CDB '80 1014 004

SUBJECT: KINGSTON STEAM PLANT - ANNUAL ASH DISPOSAL AREA INSPECTION

CDB '80 1014 003

SUBJECT: KINGSTON STEAM PLANT - ANNUAL ASH DISPOSAL AREA INSPECTION

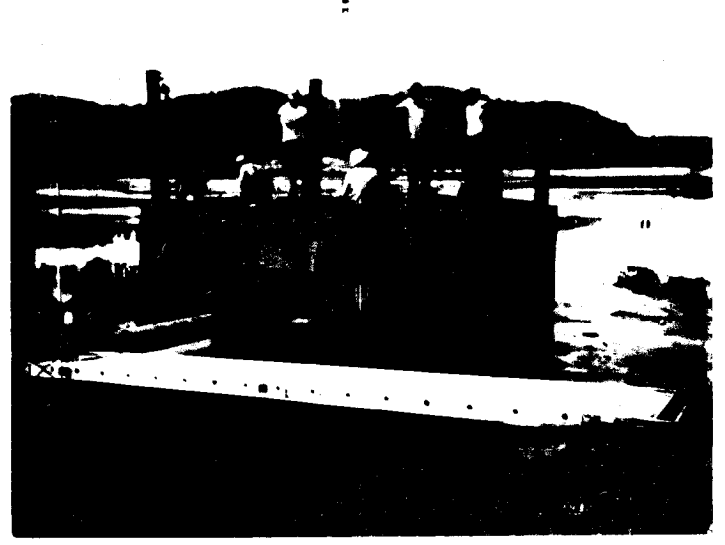
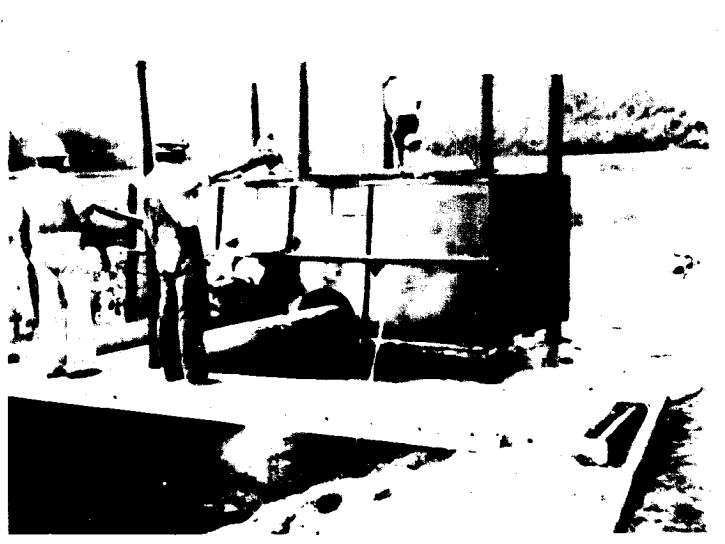
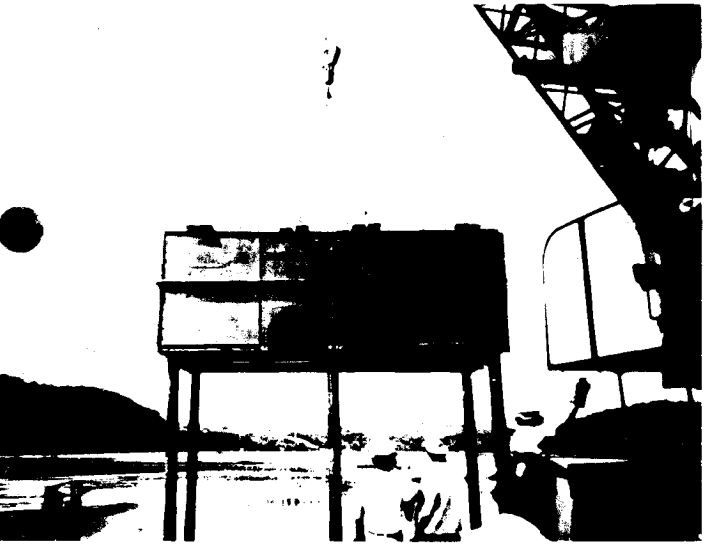
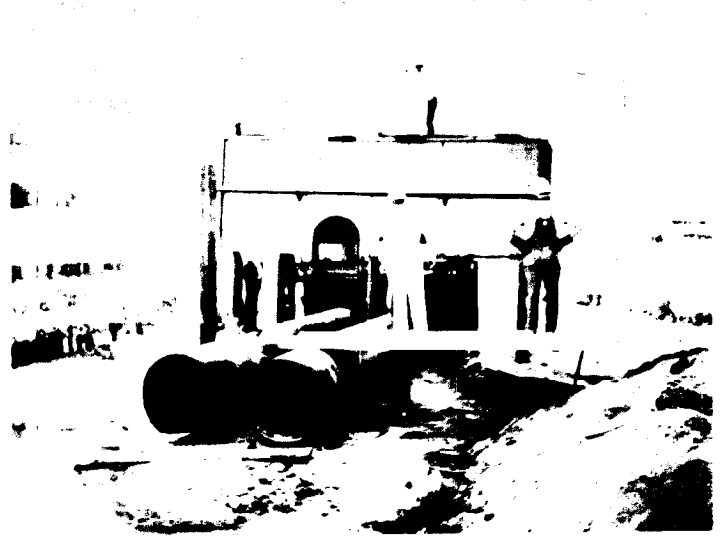
④
NOTE EVEN FLOW OF PIPES
& RIPRAP

⑤
NOTE FLY ASH SLURRY ON
STILLING POOL

⑥
NOTE AMOUNT OF SLURRY
ON UPSTREAM SIDE OF
SKIMMER

NOTE CONDITION OF DIVIDER
DIKE AND FLY ASH SLURRY

NOTE DIVIDER DIKE AND
SLURRY ON STILLING POOL

①

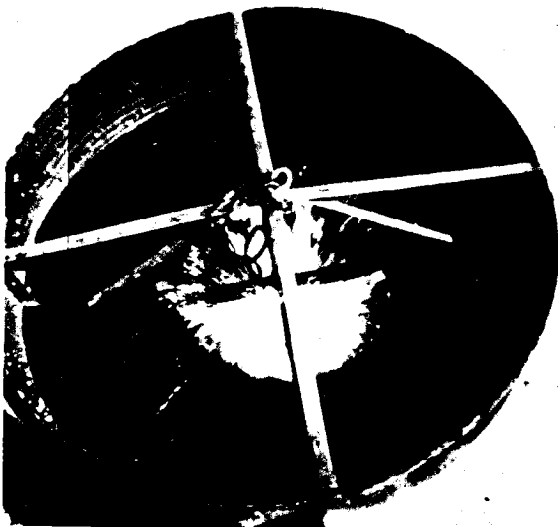
The standard spillways and skimmer in the stilling pool area appear to be in good condition and functioning properly (picture 1). The spillway outlets are discharging equally (picture 4), and the concrete end wall is in good condition. The riprap outfall to the intake channel appears to be in good condition with no sign of erosion. There was no sign of loss of ash into the intake channel. The weep holes in the concrete end wall of the spillway outlet pipes were seeping; however, the dike slope behind the end wall appeared to be dry and well compacted.

NOTE SKIMMERS, FLY ASH
SLURRY & VEGETATION
ON DIKE SLOPES

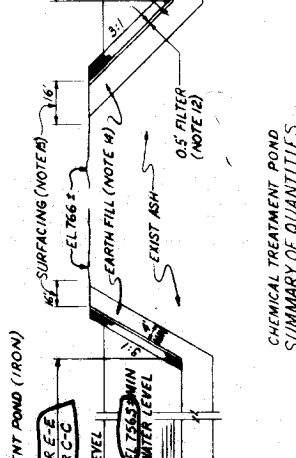
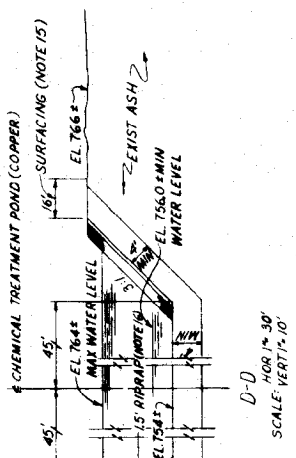
The buoyant skimmer in the divider dike flow-through spillway is not adequate to prevent ash from passing into the stilling pool area. This is due mainly to the unusually high quantity of fly ash slurry present at Kingston Steam Plant. This high quantity causes a large buildup of slurry on the upstream side of the skimmer (pictures 6 and 7) which causes an unacceptable amount of fly ash to pass into the stilling pool area. In an attempt to alleviate this situation, plant personnel have designed and fabricated and were installing on the day of the inspection a sheet metal spillway and skimmer (pictures 9 through 15).

INSIDE OF SKIMMER
DESIGNED AND BUILT BY
PLANT PERSONNEL

PLANT PERSONNEL ASSEMBLING
THEIR SKIMMER

NOTE AMOUNT OF SLURRY
OUTSIDE SKIMMER AND
CLEAR WATER INSIDE
SKIMMER

PLAN-RAISING ASH DISPOSAL AREA DIKE

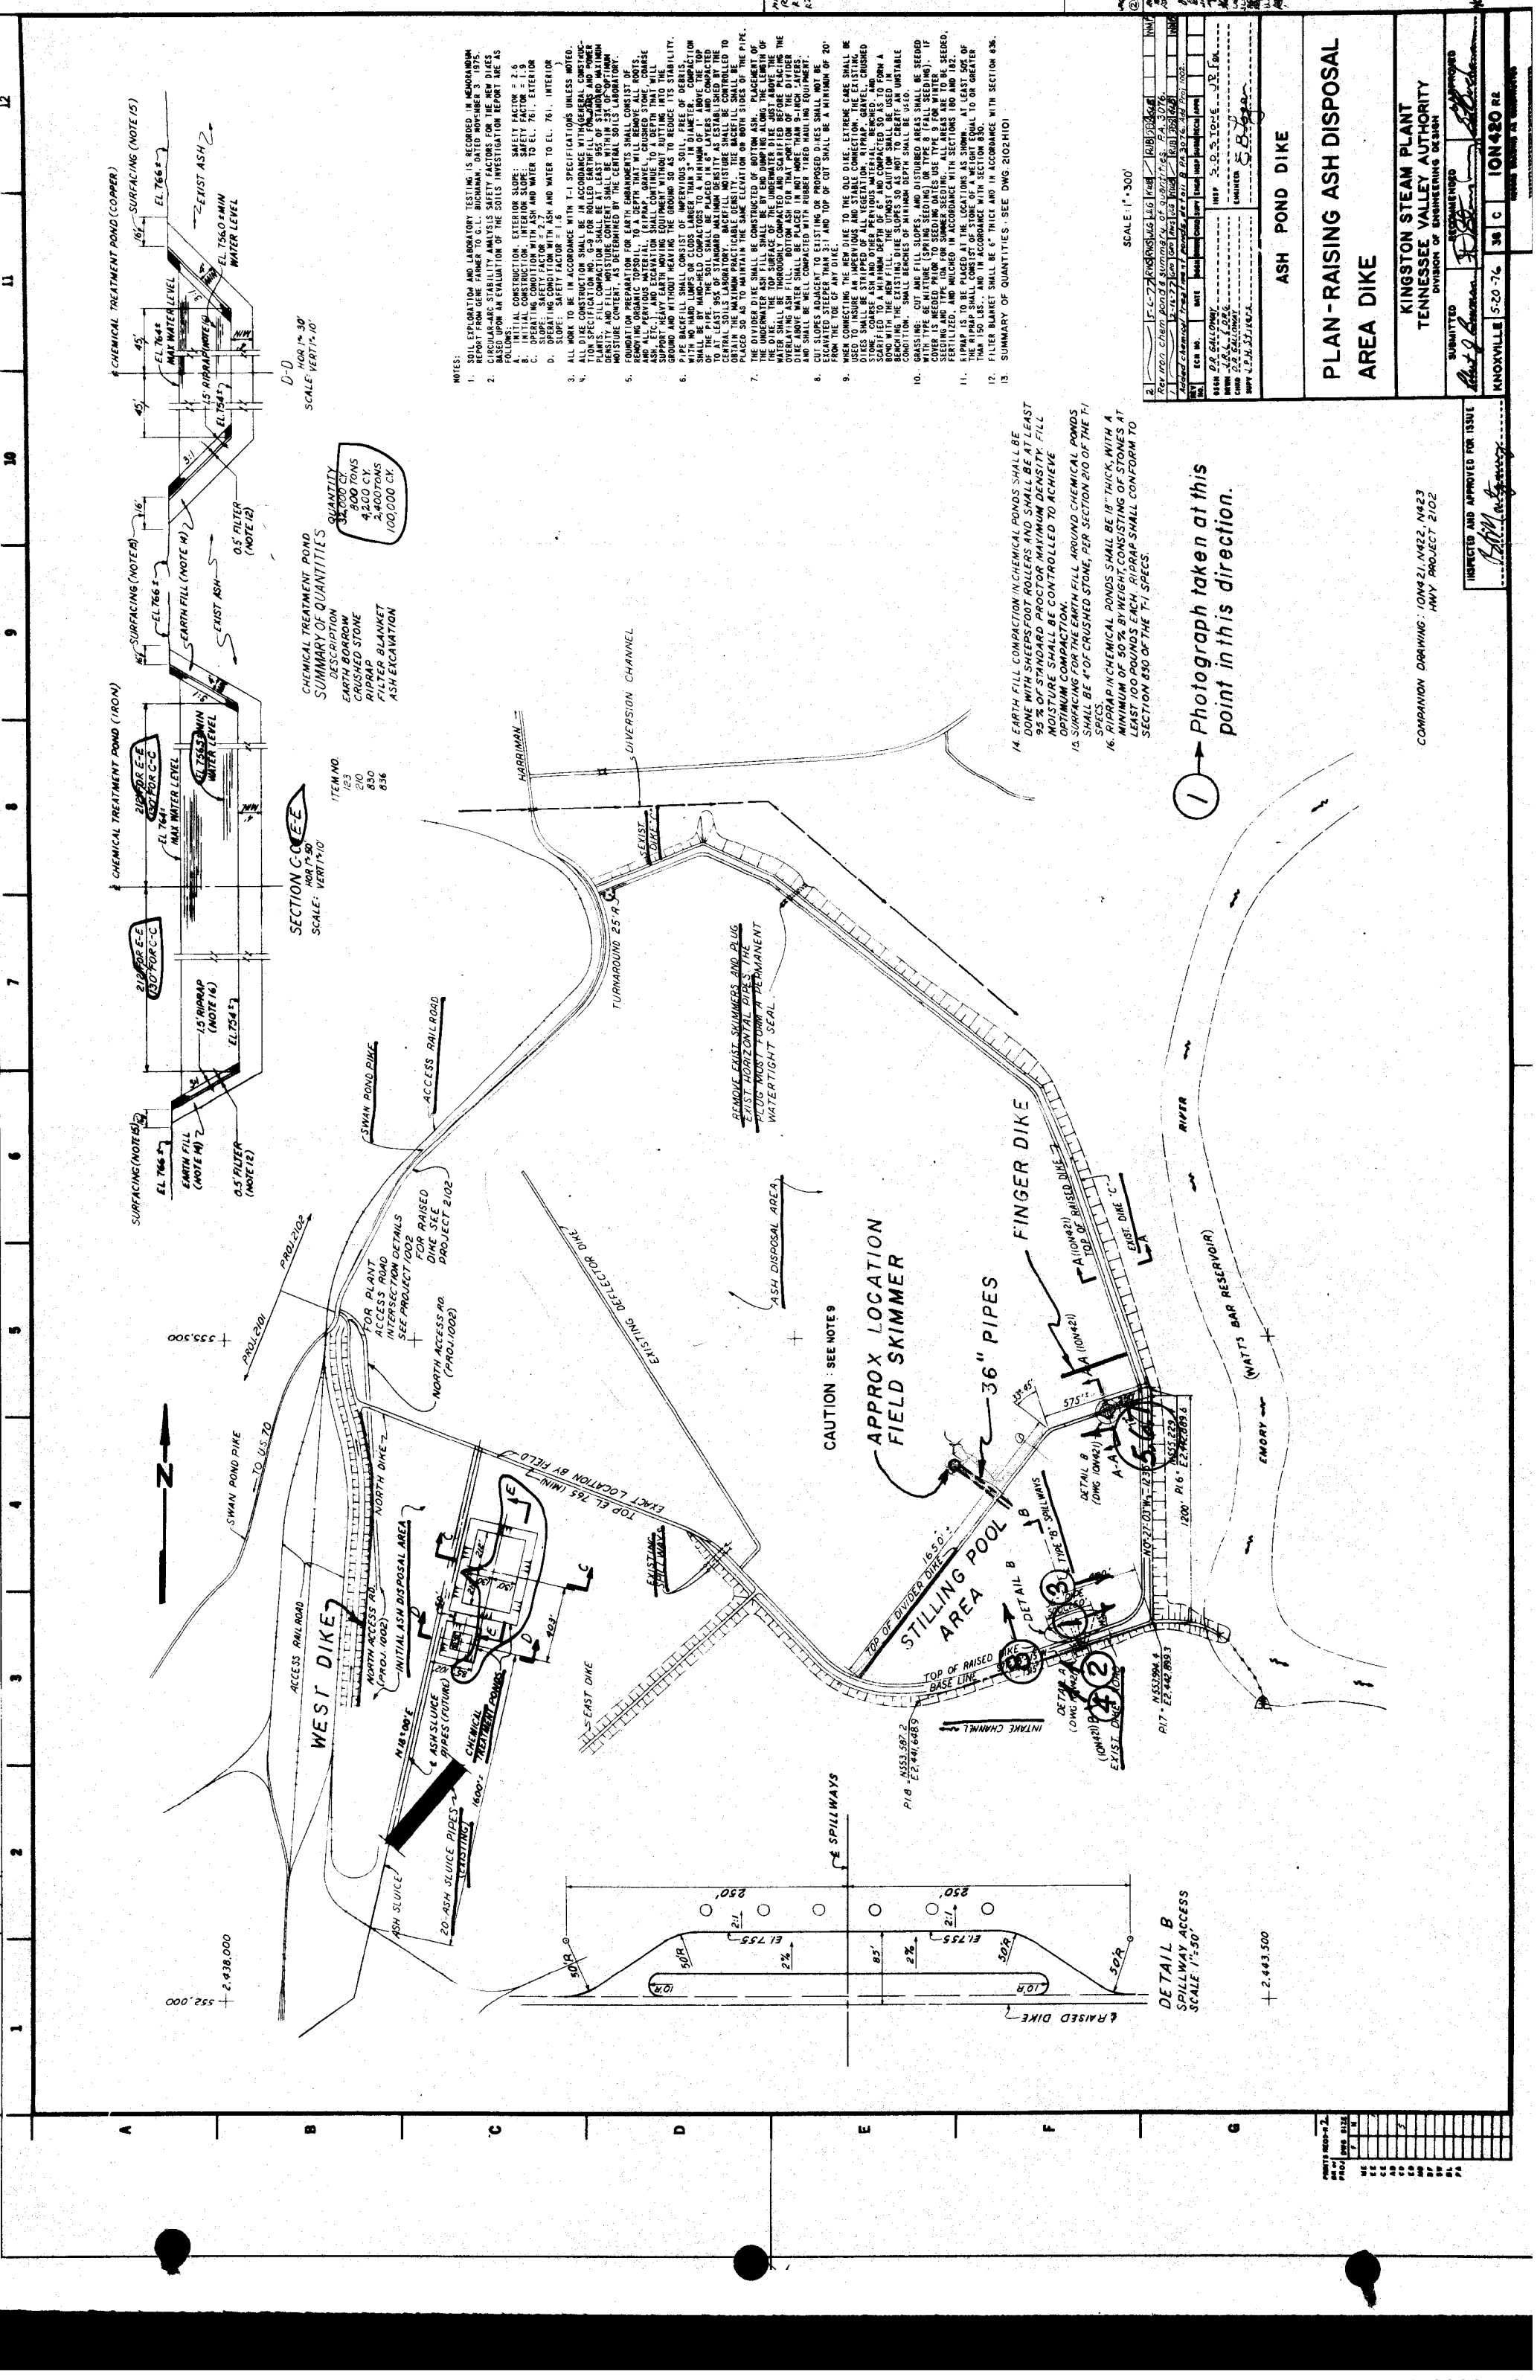
On the attached print of drawing 10N⁴²⁰₂₄₀, the different areas are designated.

A small area of surface wetness was observed at the toe of the exterior slope of the south end of dike C. We believe this condition is due to a concentration of rainfall surface runoff.

A finger dike of bottom ash has been constructed parallel to and 200± feet north of the east end of the divider dike. This finger dike provides some relief from the effects of wave action and wind load on the buoyant skimmer in the divider dike flow-through spillway; however, this has not helped to reduce the amount of floating ash that passes into the stilling pool.

Fertilize and reseed all areas of the dike slopes where an adequate vegetative cover has not been established, with type 6, mixture E, in accordance with sections 180 and 182 of the T-1 Specifications.
